Technical Bulletin

Bulletin Number: 220 Revision Number: R-03

SUBJECT: COIN INSERT SLOT CHANGES

MODELS AFFECTED: All Dixie-Narco Venders.

VRV Coin Insert
0001-6123BR and higher

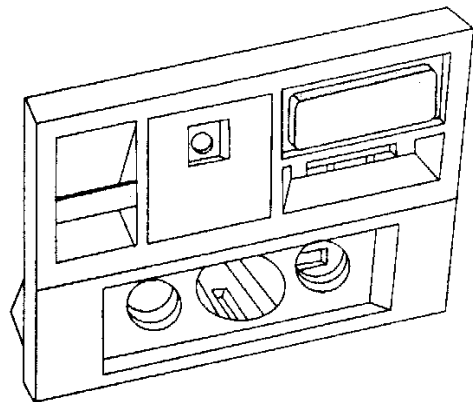
- Domestic Coca-Cola VRV Coin Inserts with Mounting Geometry Non SII (801,807,20x.x1) - \$1 coins **will** fit the insert starting production on 1/15/1998 (6475AW and higher).

- Domestic Coca-Cola VRV Coin Insert with Mounting Geometry SII (801,807,22x.x1) - \$1 coins **will** fit the insert starting production on 10/10/1997 (6445DV and higher).

- Domestic Pepsi/Generic VRV Coin Inserts with Mounting Geometry Non SII (801,807,69x.x1) - \$1 coins **will** fit the insert starting production on 10/21/1997 (6443DV and higher).

- Domestic Pepsi/Generic VRV Coin Inserts with Mounting Geometry SII (801,807,71x.x1) - \$1 coins **will** fit the insert starting production on 10/14/1997 (6444DV and higher).

- Prior to the serial breaks listed above in VRV machines the \$1 coins **will not** fit. You will need to order and install the Coin Insert Mounting Geometry's by part numbers as listed.

Coin Insert
Prior to VRV

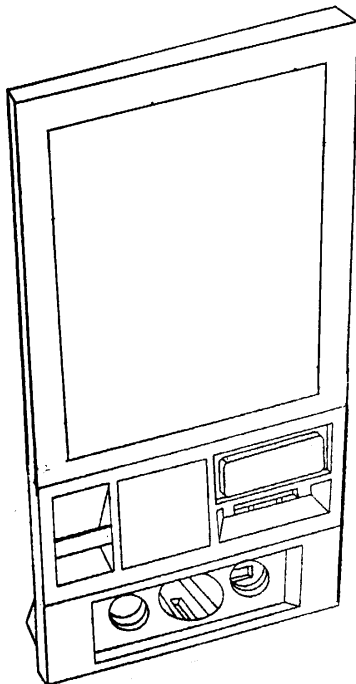
- Coin inserts prior to VRV on machines serialized August 1976 (CA) to 0001-6123BR, the corners of the coin insert need to be filed to allow the \$1 coin to fit the inserts. Some venders built between 0001-2286BD and 0001-6123BR the slot was made large enough for the \$1 coins to fit.

- On venders built prior to August 1976 (CA), the coin insert slot is large enough to take a half-dollar (50¢) piece; therefore, \$1 coins will also fit these inserts.
